TECHNICAL NOTES SERIES

JOWETT JAVELIN – PA, PB, PC, PD & PE

JOWETT JUPITER – SA & SC

PART III – SERVICE BULLETINS – JAVELIN AND JUPITER

Figure 1. Location of grease release hole.

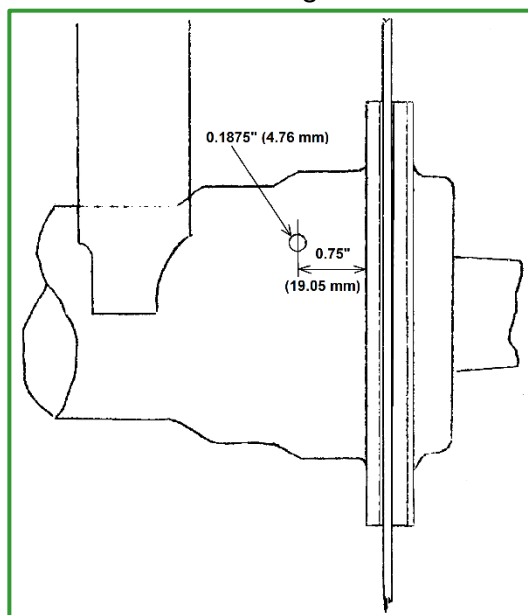
Cases have been reported where an over application of grease to the rear hubs has resulted in brake lining contamination and subsequent brake inefficiency. A $\frac{3}{16}$ " (4.7625 mm) diameter grease relief hole will shortly be incorporated for all rear hub bearings at the rear and outer (hub) end of the axle casing tubes, as shown in the sketches below:

When greasing rear hubs embodying this feature, hubs should be lubricated until grease just appears from the relief hole.

Right: Figure 2. Section through rear axle tube, showing angle of grease hole.

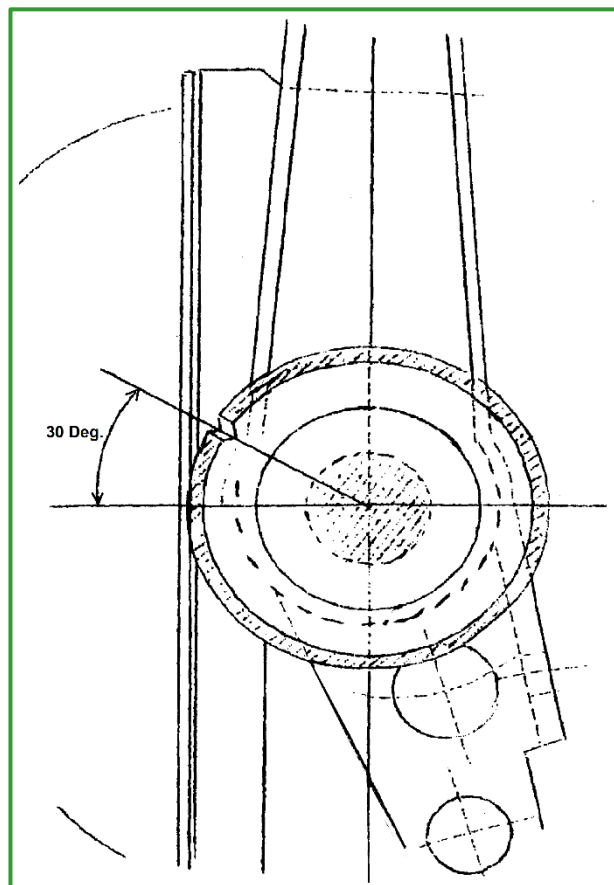
Side elevation sketch, refer to *Figure 2* at right.

Right: Figure 1. Detail of clearance cut out at cylinder liner.

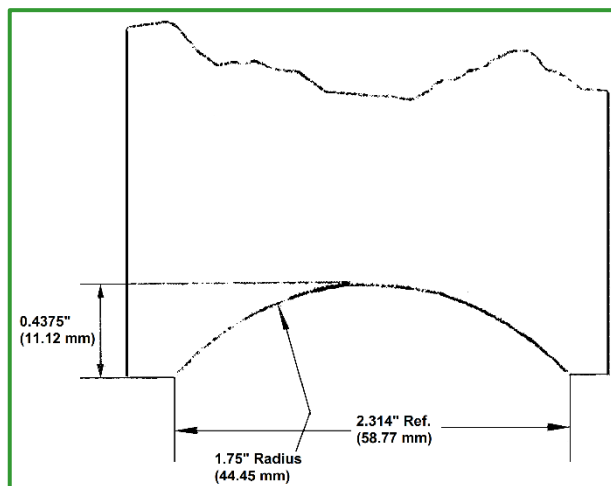
From Engine Number E0 PB 10506 a new type of connecting rod, Part Number 54024, has been incorporated in the Javelin engine. It should be noted that the mating faces of the connecting rod and the connecting rod cap are serrated to ensure a more accurate re-assembly of these parts after dismantling.

When fitting the new type connecting rod to engines previous to number E0 PB 10506 or when replacing cylinder liners in engines fitted with the new type connecting rods, it is most **important** to check the clearance between the connecting rod and the skirt of the cylinder liner. The liner cut out may be modified as detailed in the sketch below.

Right: Figure 1.

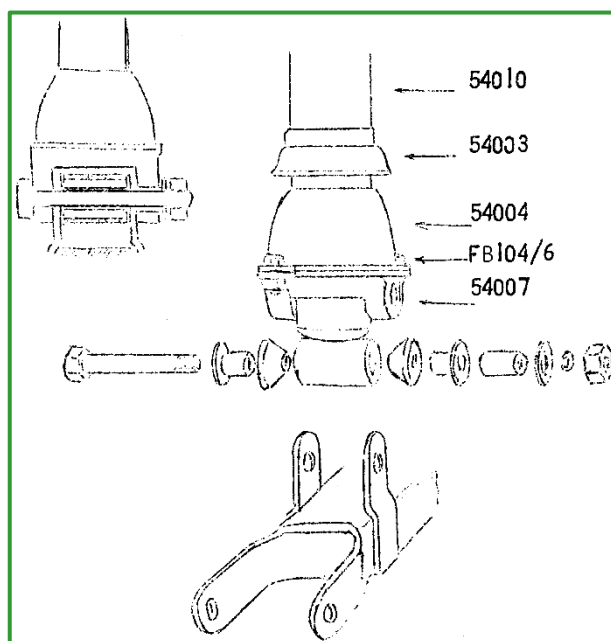
From Engine Number E0 PB 9877 a new type of front shock absorber has been fitted to Javelin cars. These units incorporate a re-designed lower fixing arrangement which reverses the position of the shock absorber buffer as shown in the sketch at right.

It will be noted that the buffer assembly is cut away to provide clearance for the stub axle in the rebound suspension position.

Right: Figure 1. Steering ball joint components.

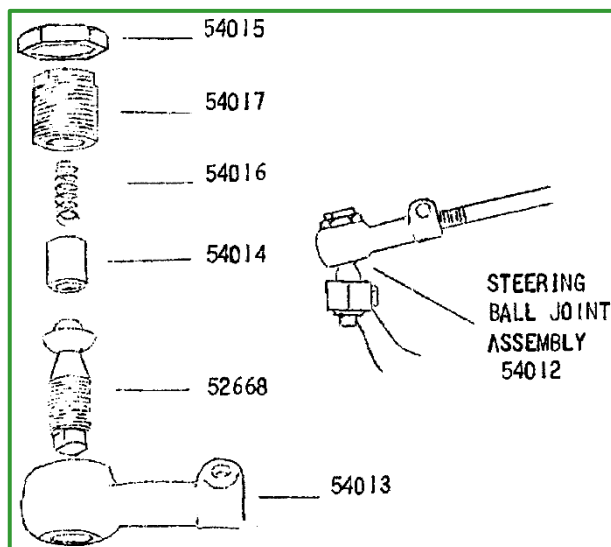
A re-designed steering ball joint assembly, Part Number 54012, has been fitted to all Javelin cars with effect from Engine Number E0 PB 10789, as shown in the sketch below:

The new assembly has been designed for ease of dismantling and is fully interchangeable with the previous type of steering ball joint assembly. To adjust the spring tension, release the lock nut, Part Number 54015, and screw the spring retaining nut in a clockwise direction until solid. From this point release the spring retaining nut a quarter of a turn and lock with the lock nut, Part Number 54015.

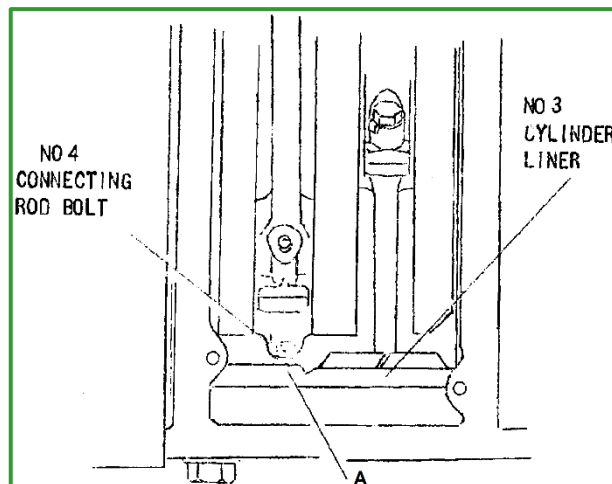
With the introduction of the new type of connecting rod, Part Number 54024, which is slightly larger in out-side diameter than the type previously used, Part Number 50650, a flat has been machined on the crankcase boss situated at the rear of number 3 cylinder base inside the LHS crankcase. This is to ensure that there is sufficient clearance between the crankcase boss and number 4 connecting rod bolt.

there is adequate clearance between the crankcase boss and number 4 connecting rod bolt. Should any doubt exist, a flat may be filed on the crankcase boss as shown in the illustration on the next page. After carrying out this modification great care should be taken to remove all traces of filings etc., from inside the crankcase.

Right: Figure 1. Adjustable gear change links.

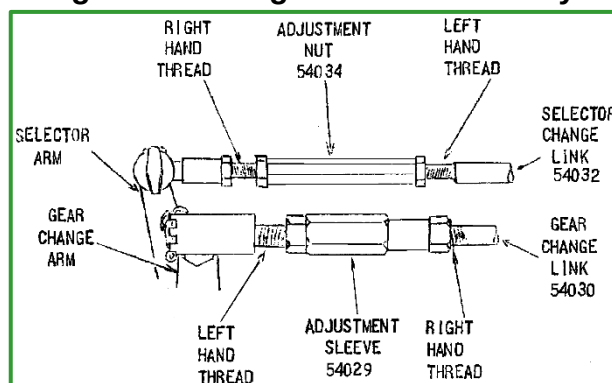
From Engine Number E0 PC 12340 new type adjustable selector, Part No. AS54031, and gear change, Part No. AS54027, link assemblies have been fitted between the gear change column and gearbox on R.H.D models only. This modification allows a finer and increased range of adjustment on each rod.

Adjustment: The adjustment nut, Part No. 54034, on the selector change link and the adjustment sleeve, Part No. 54029, on the gear change link are provided with left and right hand threads

which allow the link to be lengthened or shortened by turning the nut or sleeve after the locknuts have been released. Please refer to the illustration above. The direction of rotation for adjustment works in opposite directions on each link i.e. to lengthen the selector change link the top of the adjustment nut should be turned away from the operator, whereas to lengthen the gear change link the top of the adjustment sleeve should be turned towards the operator.

Figure 1. Modified air cleaner bracket arrangement.

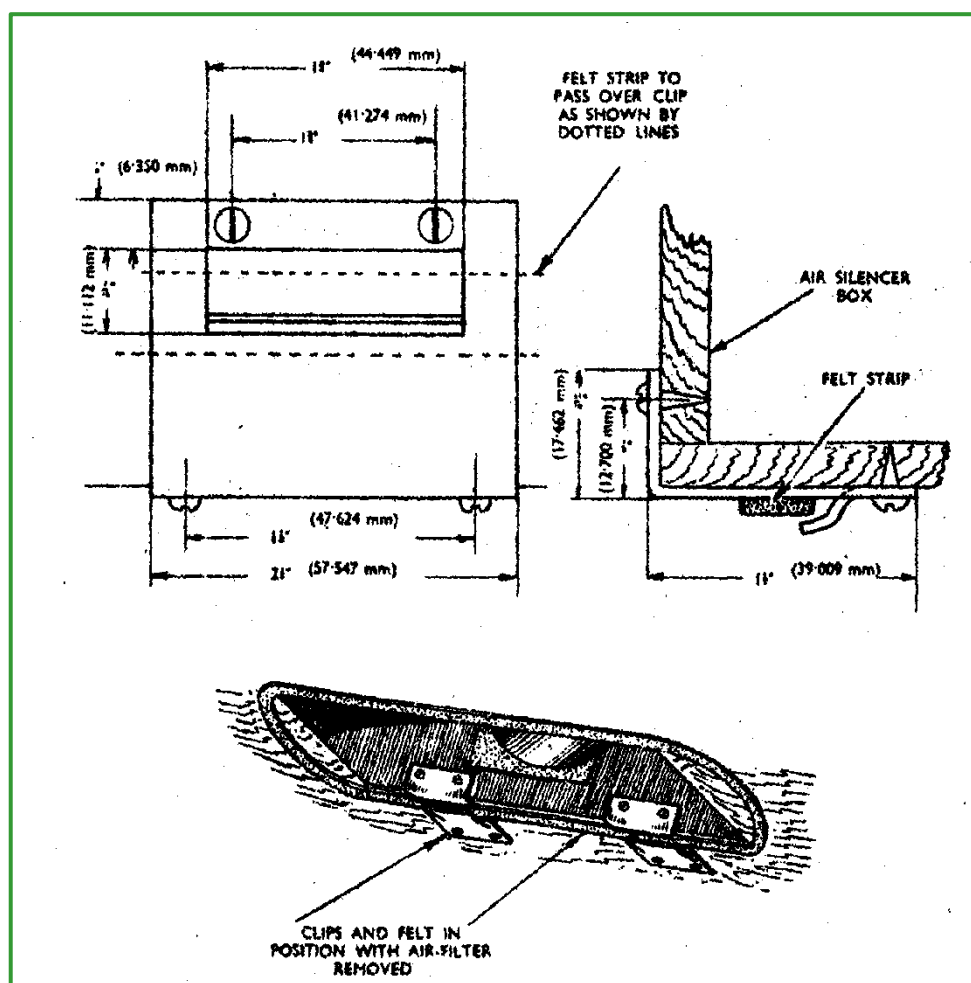
With effect from Engine Number E0 PB 8950 the woodscrews which secure the air filter brackets to the air silencer base, have been replaced by threaded screws and rivet nuts. On cars prior to the above Engine Number where difficulty is experienced with the original filter mounting, modified securing brackets may be fitted. This type of bracket, Part Number 54237, is held firmly in position by four wood screws set at right angles to each other, as shown in Figure 1.

Right: Figure 1. Location of sludge release hole.

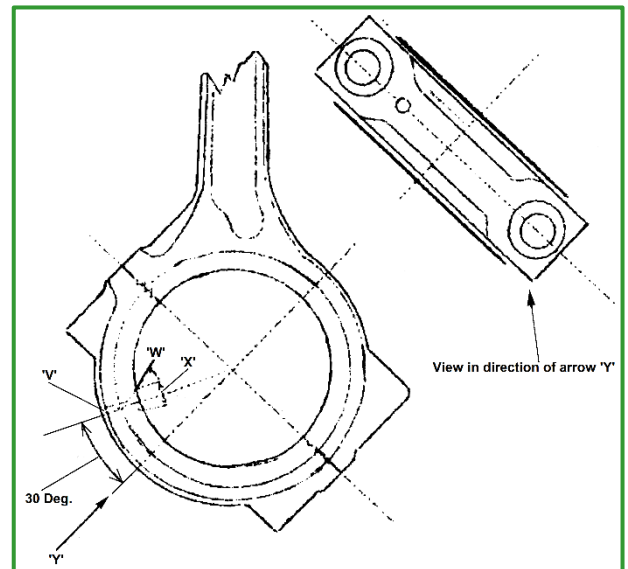
From investigations we have recently carried out, we consider it desirable to incorporate a sludge release hole in the connecting rod cap and bearing. This modification has been incorporated from Engine Number E1 PC 17402, and takes the form of a $\frac{1}{16}$ -in. (1.5873 mm) hole drilled 30° off centre of the connecting rod cap.

When vehicles prior to Engine No. E1 PC 17402 are in your service department for engine repairs, the opportunity may be taken to carry out the connecting rod modification as detailed in *Figure 1*.

Right: Figure 1. Starter ring gear modification.

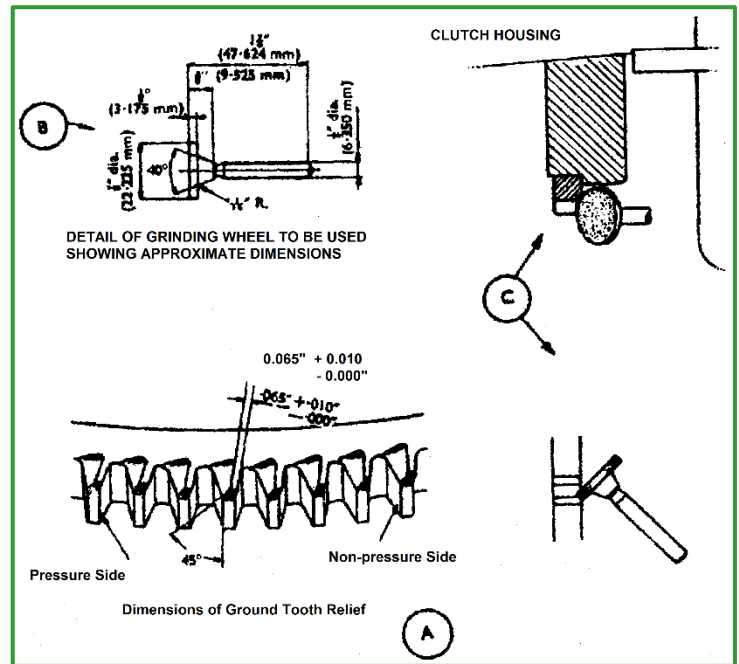
An increased tooth chamfer which runs parallel with the pressure side of the ring gear tooth is now incorporated on all flywheel ring gears fitted to Javelin and Jupiter cars. This modification gives improved 'lead-in' for the starter Bendix drive gear thereby cutting down to a minimum any tendency for the flywheel ring gear teeth to become burred or damaged due to initial contact between the two gears.

Above: Figure 1. Mounting of competition type oil cooler (with Tecalemit oil filter).

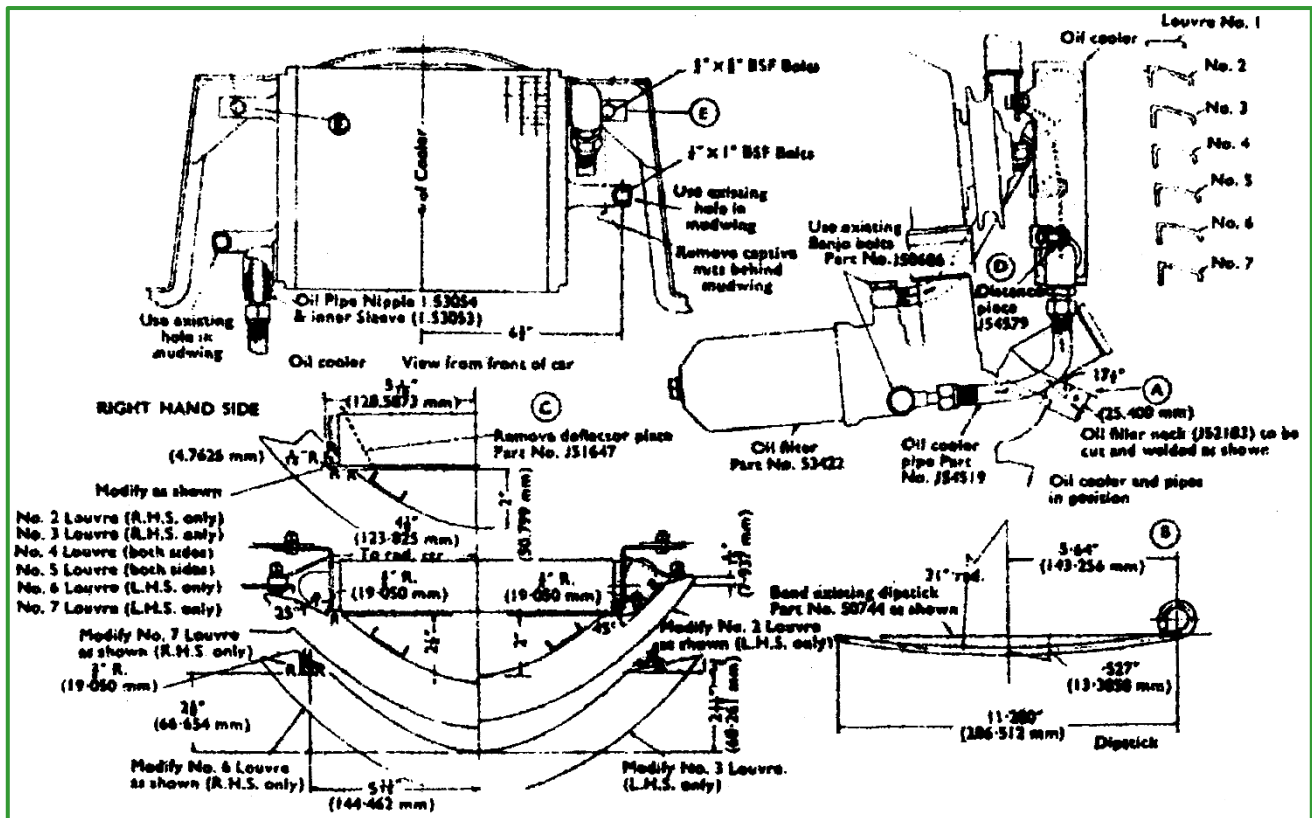
1. Remove the oil filler tube and modify to the dimensions given at (A), so that it will clear the cooler. See *Figure 1*, Page 45.
2. Shape the dipstick to the dimensions at (B), so that it clears the oil cooler when being withdrawn or being replaced. See *Figure 1*, Page 45.
3. Remove the radiator grille and remove the deflector plate as shown at (C) *Figure 1*. Cut away the portions of the grille portions as shown, so that there is clearance between the oil cooler and the Grille. If the grille is of the early type with the chromium-plated louvres, no modification to the louvres is required, but it will be necessary to remove the brace frame, and to fabricate and fit a modified brace frame, as shown in *Figure 2*, on Page 45.

4. To fit the cooler, remove the captive nuts at the rear of the mud-wing and drill the lower cooler brackets to coincide with the existing holes in the mud-wing and secure with two $\frac{1}{4} \times 1$ -in. BSF bolts and nuts with the distance pieces positioned between the lower cooler brackets and the mud-wing as shown at (D) in Figure 1.

Drill the grille frame corner pieces and top cooler bracket holes and secure with the use of two $\frac{1}{4} \times \frac{5}{8}$ -in. BSF bolts as shown at (E) in Figure 1.

5. Fit the cooler pipes in position as shown in Figure 1, using the existing banjo bolts and fibre washers at the rear timing cover connections.

Figure 3a. Vokes oil filter modification.

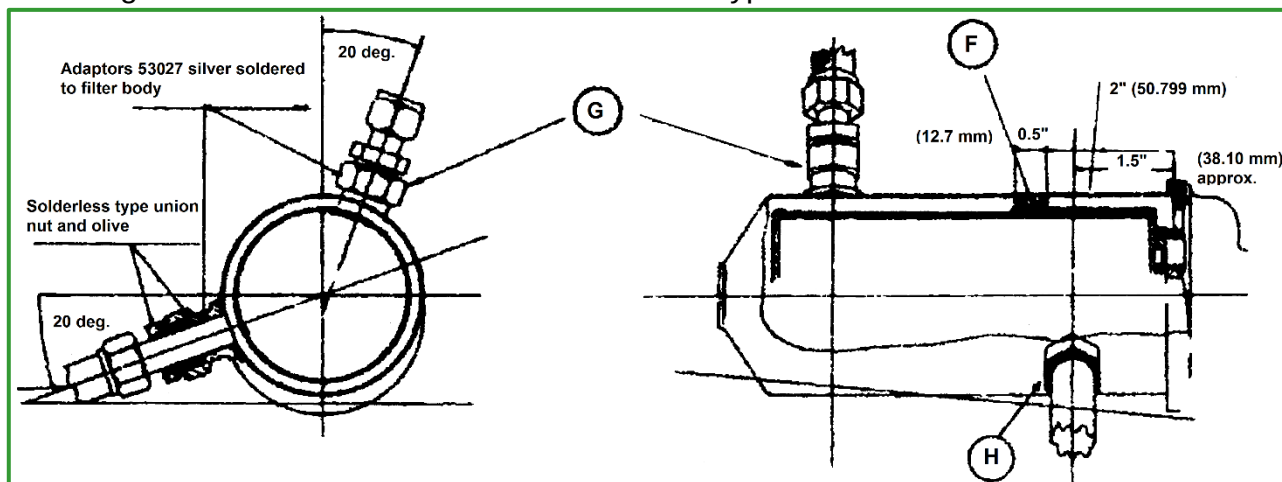
1. Fit the blanking ring, Part Number 53046, to the oil filter case as shown at (F) *Figure 3a* and secure in position by riveting or sweating, do not weld or braze as this method would tend to cause distortion.
2. Drill two ½-in. (12.70 mm) holes in the filter case in the positions shown at (G) and (H) in *Figure 3a*, and fit the oil cooler pipe adaptors, Part Number 53027. Secure the adaptors to the case with silver solder.
3. Butt solder the shroud, Part Number 53045, as shown at (J) *Figure 3b*, and after removing the three lugs from filter element front plate, sweat the shroud to the front plate in the position shown at (K) *Figure 3b*.

Figure 2. Installing Lucas DKY H4A distributor on later type timing cover.

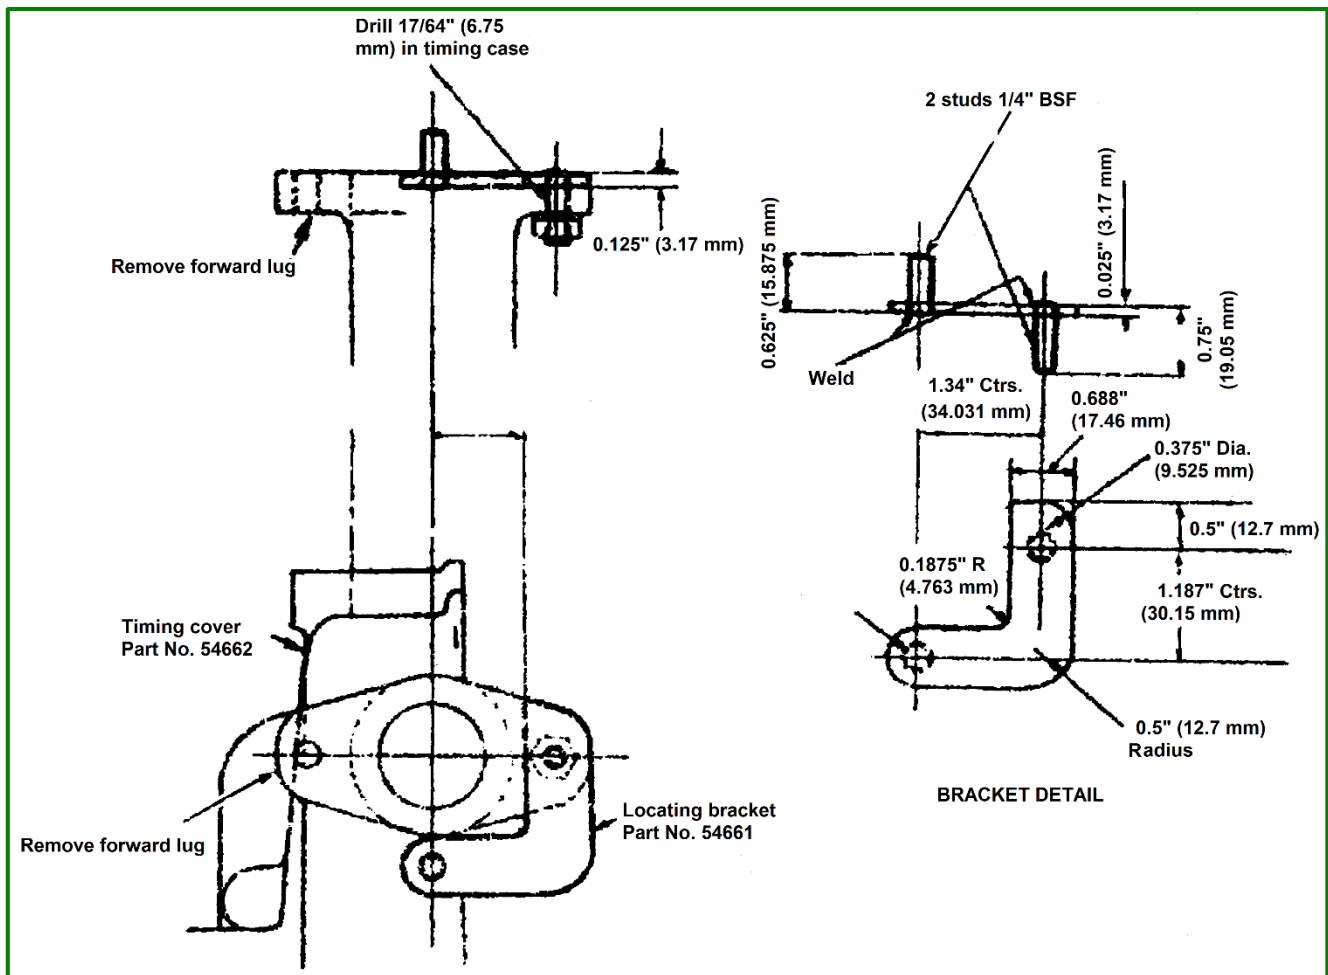
The old type distributor (DKY H4A) can be fitted to the new type timing cover by removing the forward lug of the timing cover mounting flange and fitting a distributor locating bracket, Part Number 54661, to the rear lug of the timing cover mounting flange as shown in *Figure 2*.

Figure 1. Dimensions for drilling fan support tube.

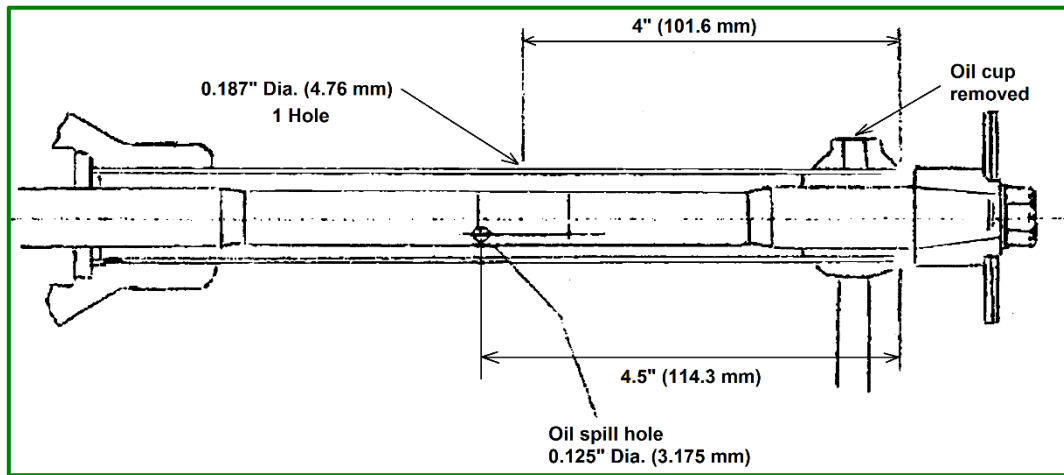
With the introduction of the radiator mounted oil cooler the fan support tube oil cup, Part Number J54011, was inaccessible and therefore removed. A $\frac{3}{16}$ -in. (4.763 mm) hole is now incorporated in the fan support tube for lubrication purposes together with a $\frac{1}{8}$ -in. (3.175 mm) spill hole to prevent over lubrication.

Right: Figure 1. Installation of modified body mounting.

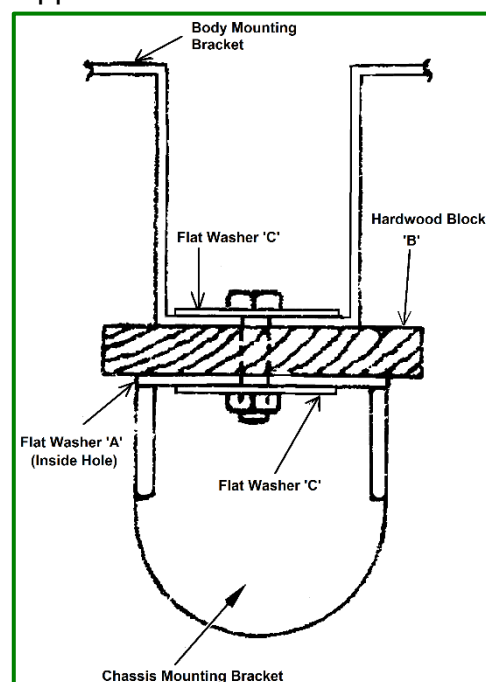
1. Remove the bonnet and front wing assembly, windscreen wiper motor, starter solenoid and horn relay on R.H.D models, the wiper motor on L.H.D. models, and the four Silentbloc bushes of the front and centre body mountings. Where the Vokes type air cleaner is fitted on the dash panel, it will be necessary to remove and fit the two independent air cleaners.
2. Place a ½-in. (12·7 mm) flat washer, with outside diameter 1½-in. (38·099 mm) by ⅜-in. (2·38 mm) thick, 'A', into the existing holes in the body support bracket assemblies on the chassis to centralise the mounting bolts in the brackets. Refer to *Figure 1*.

3. Cut four hardwood blocks 'B', *Figure 1*, 3 x 3 x ⅞-in. (76·2 x 76·2 x 22·23 mm) and drill a ½-in. (12·7 mm) hole in the centre of each. Fit the blocks in place of the Silentbloc bushes, ensuring that the grain of the wood is at right angles to the chassis frame, refer to *Figure 1*.
4. Fit ½ x 2-in. body mounting bolts with ½-in. flat washers of 2-in. outside diameter by ⅜-in. thick beneath the head of each bolt and fit ½-in. Oddie (Nyloc) nuts together with washers of the previous dimensions, refer to 'C' *Figure 1*.
